Staff Report & Recommendation

Design Review Board

SUBJECT: **DRB19-0462**
6961-6985 Abbott Avenue, 300-326 71st Street, and 6972 Harding Avenue

The applicant has submitted plans entitled "6985 Abbott Avenue: Final Submittal" as prepared by **cube3, LLC** dated signed and sealed March 09, 2020. The applicant is proposing a new 14-story, 149'-2" high building with 118 residential units, including one or more waivers and multiple variances. A breakdown of the project's development plan is delineated hereto:

Overall Site

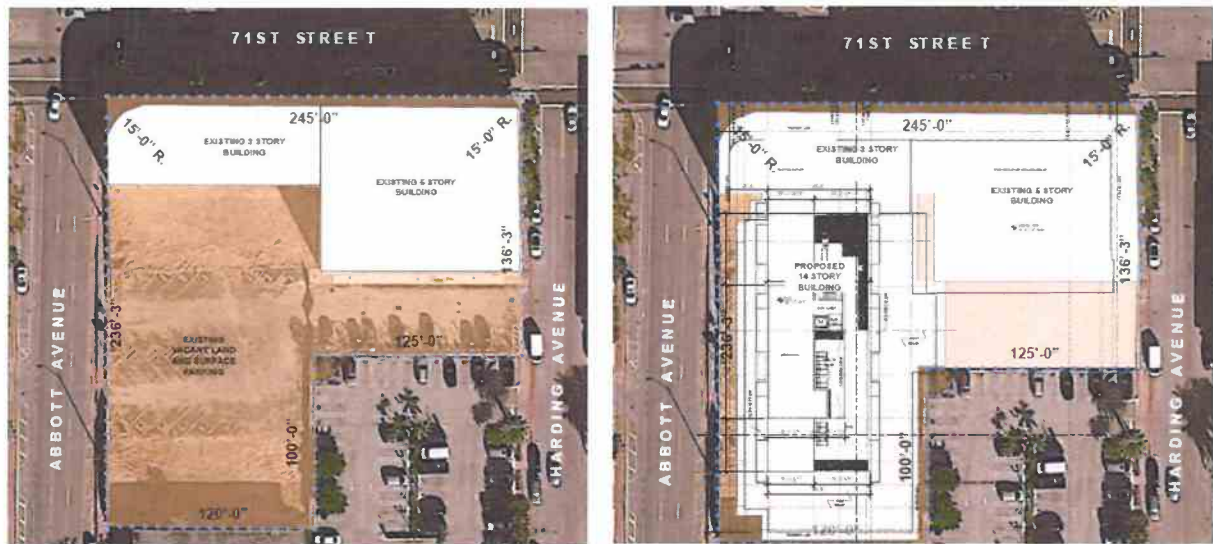
The subject site is a 1.13-acre unified development located within the boundaries of the TC-C, Town Center – Central Core District. The applicant is proposing a new 14-story, 149'-2" high building with 118 residential units above a ground floor retail component. The site is generally bound by 71st Street to the north, Abbott Avenue to the west, and Harding Avenue to the east. Except for the parcels fronting 71st Street, the rest of the site is vacant and unimproved, including a surface parking area ancillary to the bank.

As previously mentioned, staff is strongly opposed to the proposed ground floor site plan, as it includes the retention of the existing surface parking area. To allow the waiver to add a driveway onto the Class B street (Abbott Avenue) would be an endorsement of the undeveloped site plan as it pertains to vehicular maneuverability. The proposed site plan repurposes the existing surface parking area behind CNB building and restripes it for parking, adds an outside loading space and acts as a drive through access to the building.

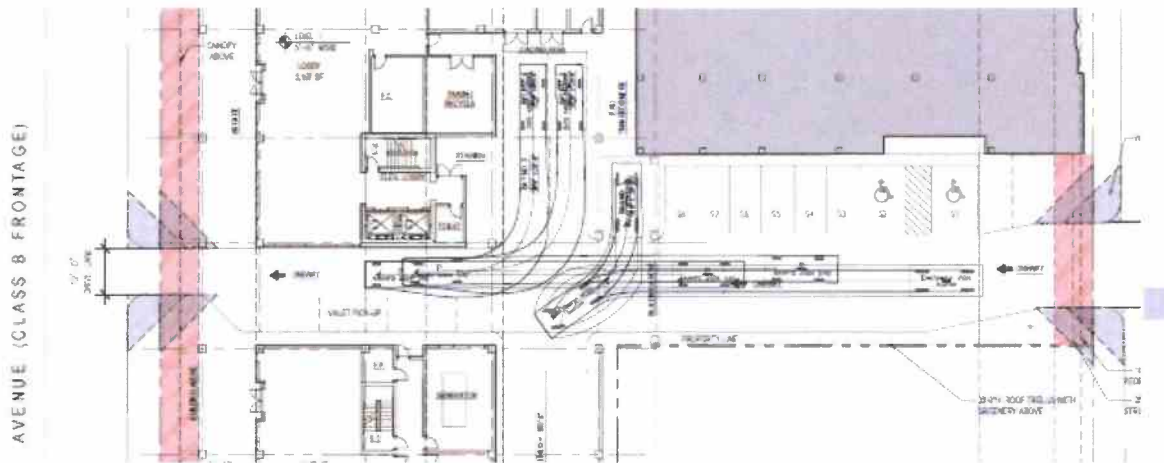
A five-story parking pedestal facing Abbott Avenue features a ground floor elevation with 28'-0" high floor to ceiling glass, for a spacious retail and lobby component, recessed below four stories of architectural screening at the parking levels. The lower levels of the garage are screened with concrete/stucco 'dynamic' apertures, or rectangular stucco frames with walls tapering inward to recessed openings of varying shapes creating a dynamic wall plane. This lower level aligns with the elevation height of the neighboring Gidney building. The screening along the upper levels of the garage exhibits

a diminutive pattern of the dynamic openings executed with concrete breezeblocks.

The tower contains floor to ceiling glass along its expansive east and west elevations, and feature projecting glass balconies that stagger at every other floor and extend past the tower's vertical walls. The cantilevering of the balconies coupled with their staggered rhythm, lends the glass façades movement and interest. In contrast, the slender, north and south elevations are predominately finished in white stucco with vertical ribbons of fenestration and compliment the prominent elevations. The project extends to Harding Avenue, with the site south of the City National Bank proposed as a vehicular entrance and a surface parking lot.
